APPLICATION NO.	FILING DATE	FIRST NAMED INVENTOR	ATTORNEY DOCKET NO.	CONFIRMATION NO.
10/627,623	07/28/2003	Reuven Unger	P23593	4331
7055 7590 06/03/2008 GREENBLUM & BERNSTEIN, P.L.C. 1950 ROLAND CLARKE PLACE RESTON, VA 20191				
EXAMINER GARCIA, ERNESTO				
ART UNIT 3679		PAPER NUMBER		
NOTIFICATION DATE 06/03/2008		DELIVERY MODE ELECTRONIC

Office Action Summary

DETAILED ACTION

FIG. 6

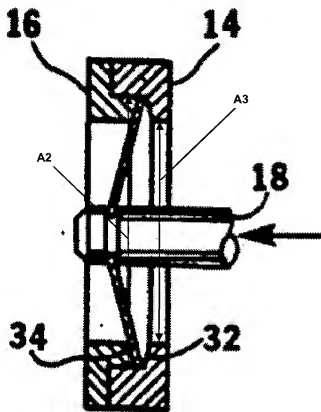
Regarding claim 10, Schwab discloses, in Figure 6, a securing device comprising a spring 12, a rod 18, a generally annular spring support 14, and a generally annular coupling ring 16. The spring support 14 includes a spring mount 32 projecting in an inner side of the spring support 14, unitarily being formed with the spring support 14, and configured to support the spring 12. The spring support 14 consists of two different inner diameters, in this order, a second inner diameter A2 (see marked-up attachment), and a third inner diameter A3 that is smaller than the second inner diameter A2. The spring mount 32 is positioned at a region of the spring support 14 located between the second inner diameter A2 and the third inner diameter A3. However, Schwab fails to disclose the support member further consisting of a first inner diameter and threaded holes penetratingly formed through the coupling ring 16.

Regarding claim 12, given the modification, a portion of a first thread would have been formed on an inner periphery of a portion of the first inner diameter. A second thread would have been formed on an outer periphery of the coupling ring **31**. The first thread and the second thread engage each other.

Regarding claim 14, given the modification, the threaded holes, as modified, would have been at an interval of approximately 90 degrees or 180 degrees on the coupling ring.
